# TOPNOTCH BUILDING INSPECTIONS

## PRE-PLASTER INSPECTION

1234 Main St. Preston Victoria 3072

### 6.3.1 Exterior Doors **FRAMES NOT FIXED**

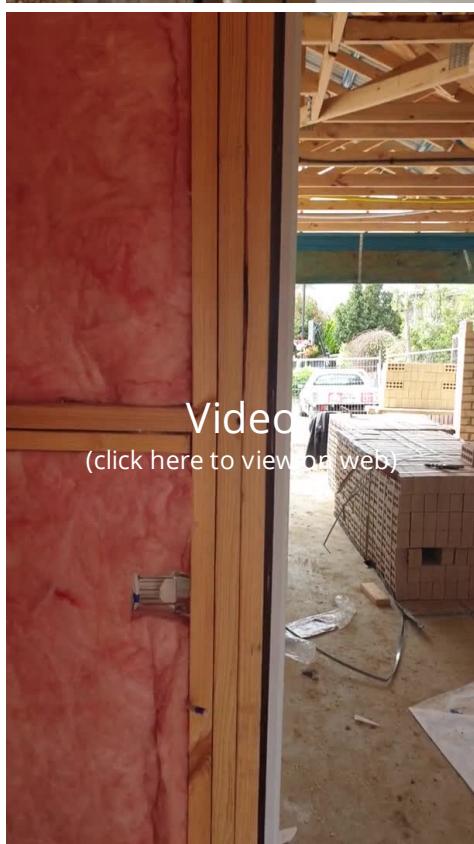
The external door frames have not been installed as per the manufacturers recommendations.

The external door frames have only been tacked in position.

I recommend installing the external door frames as per the manufacturers recommendations and in-line with the Industry Guide To The Correct Installation Of Windows And Doors. [See link here](#)

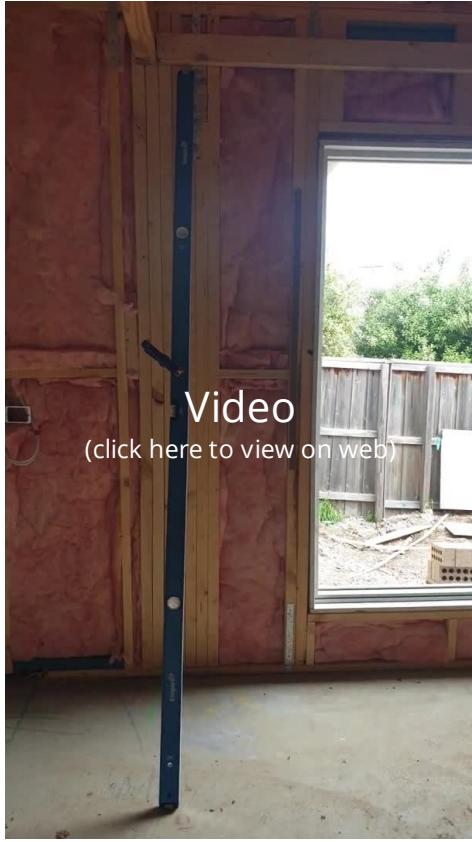
The window frames have only been tacked in position.

I recommend installing all of the window frames as per the manufacturers recommendations and in-line with the Industry Guide To The Correct Installation Of Windows And Doors. [See link here](#)

CHECK DWELLING THROUGHOUT

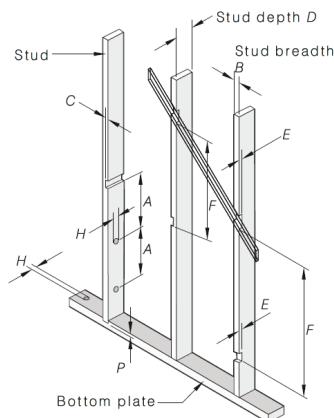
Studs have been notched for plumbing breeches in excess of the maximum size allowed by AS1684.2-2010.

The maximum notch into a stud depth is 20mm.

Recommendation  
Contact your builder.

Missing framing members for plasterboard

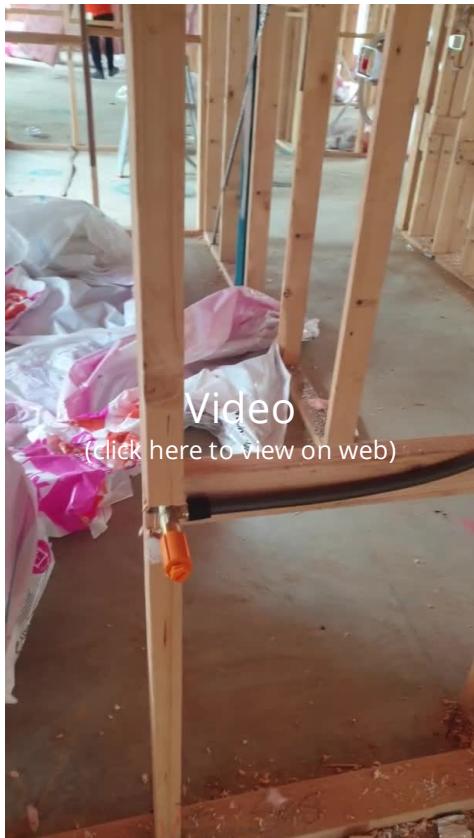
Cut stud work

Missing Noggings
